ADDRESS : 110 NEW RIVER CT
CONTRACTOR : RAYNOR BUILDERS INC
OWNER : IOM LAND COMPANY LLC #22
PARCEL : 04-0673- - -0134- -25-
APPL NUMBER: 07-50016658 CP NEW RESIDENTIAL (SFD)
DIRECTIONS : 210 E LEFT ON JAME NORRIS S/D ON RIGHT
LOT #22 JB

PERMIT: CPSF 00 CP * SFD

Re: J80014
RAYNOR/LOT 22 AUTUMN POINT

Job J80014	Truss B1A	Truss Type ROOF TRUSS	Qty 4	Ply 1	RAYNOR/LOT 22 AUTUMN POINT Job Reference (optional)	E4738821
---------------	--------------	--------------------------	----------	----------	--	----------

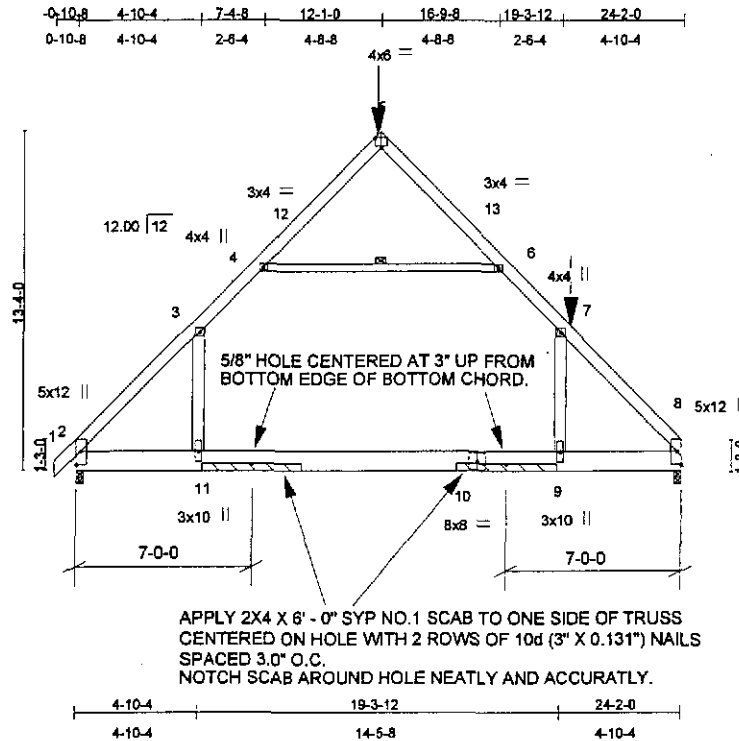
APPLY 2X4 X 6' - 0" SYP NO.1 SCAB TO ONE SIDE OF TRUSS CENTERED ON HOLE WITH 2 ROWS OF 10d (3" X 0.131") NAILS SPACED 3.0" O.C. NOTCH SCAB AROUND HOLE NEATLY AND ACCURATELY.
